# **Town of Scituate, RI**

**Scituate Animal Shelter Addition**

**Additional HVAC Information**

**Additional RFI Responses**

# SK-004

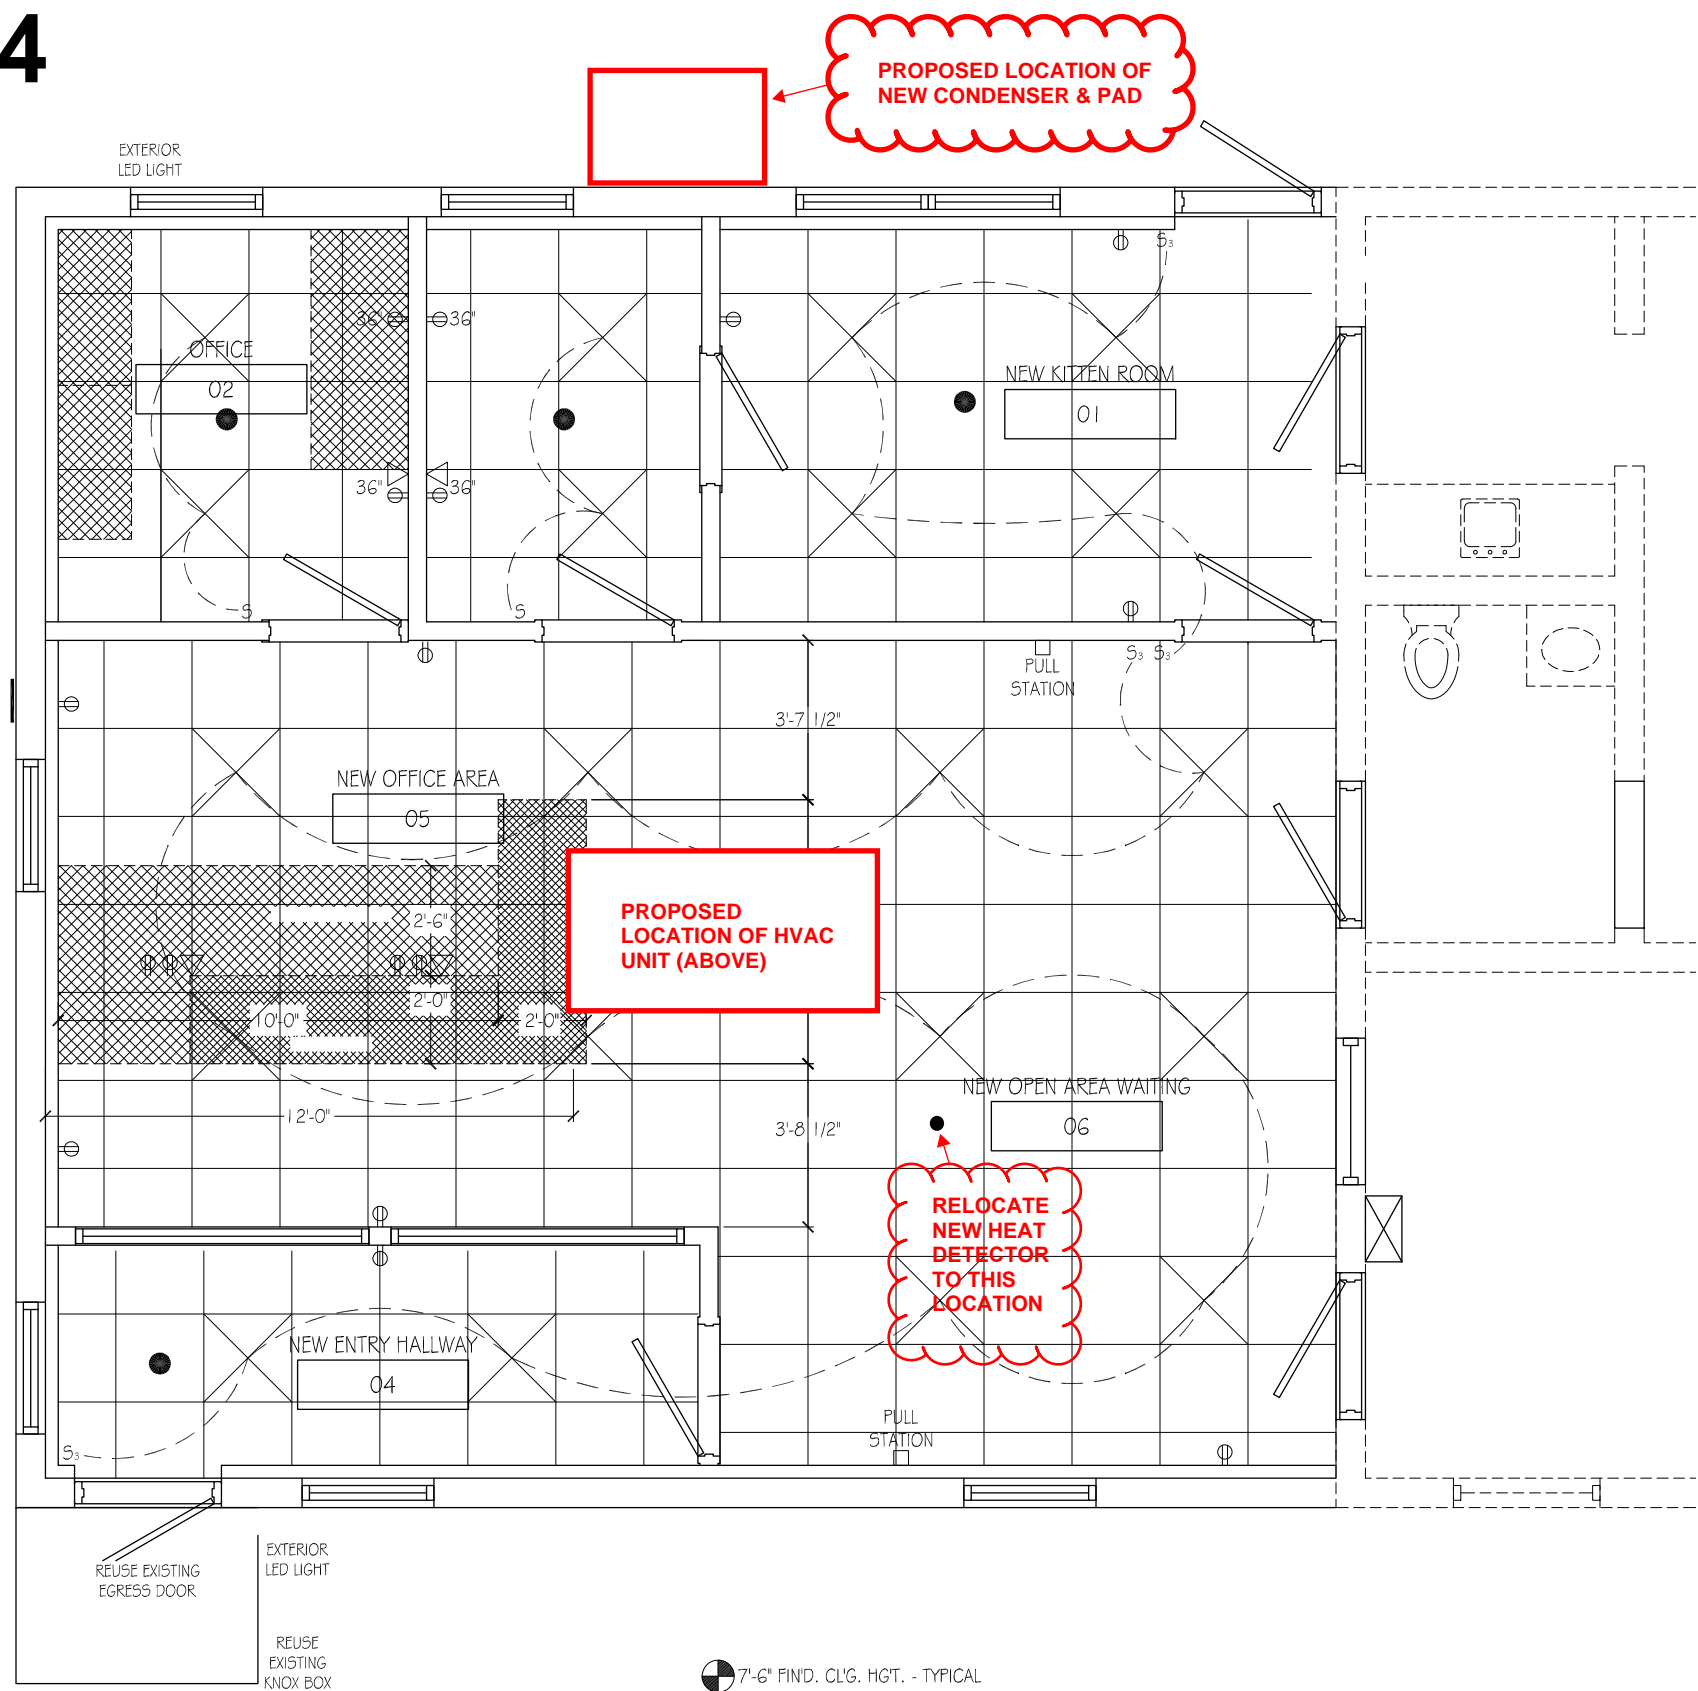
1. The scope of HVAC is unclear- please provide direction regarding specifications for size, ductwork, power requirements

Answer- The base bid HVAC scope of work is to include the following- Furnish and install one 2.5 ton hydro air system by First Company or approved equal, above grid and centered at new addition, with condenser located as shown in SK-004. Revise truss count to include min qty-6 attic style trusses at center, with balance to be traditional Fink truss. Make all provisions for drop ceiling, including retractable attic stair system. Furnish and install all duct work, including minimum one feed for each room and additional feeds as required, and one central return with additional low return in main office area. Complete system shall include line set, drains, drain pan, safety switch in drain pan, 410A condenser pad, all line voltage feeding and circuitry, all low voltage wiring, new digital heating and cooling thermostat. Include insulated connection of wet side of system to existing boiler, and include installation of new zone to boiler as needed. See SK-004 for more information.

**C**  
**06** WALL SECTION - 2x6 FRAMING

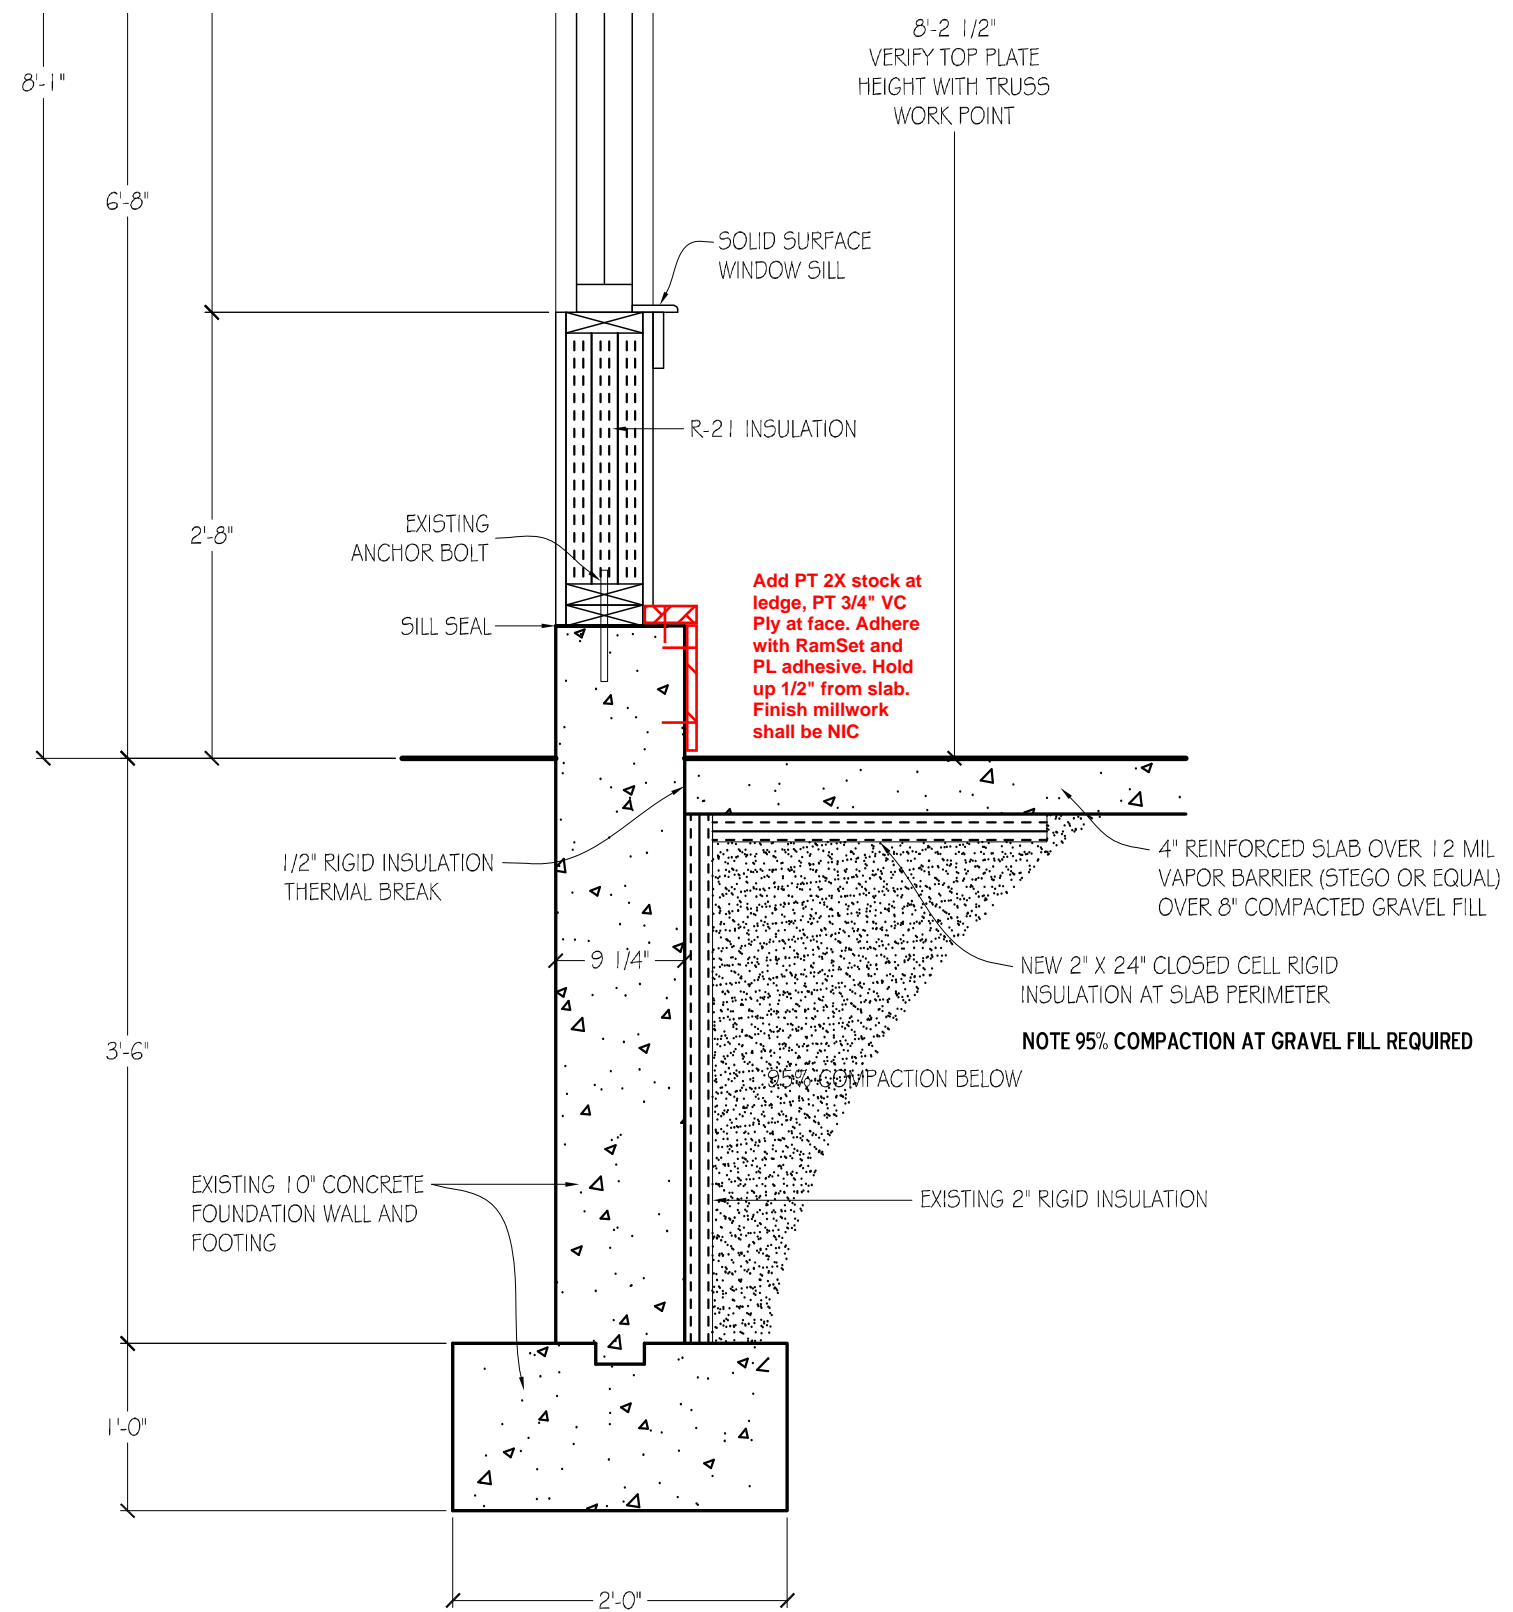
2. What happens to the foundation wall if we go with the deduct alternate? Do we strap the interior of the wall to flush the studs and bring the GWB down to the slab or leave the lip as is?

Answer- Apply PT dimensioned stock and ¾" plywood as indicated. Insure secure adhesion and flush joints. See SK-005-C/06REV
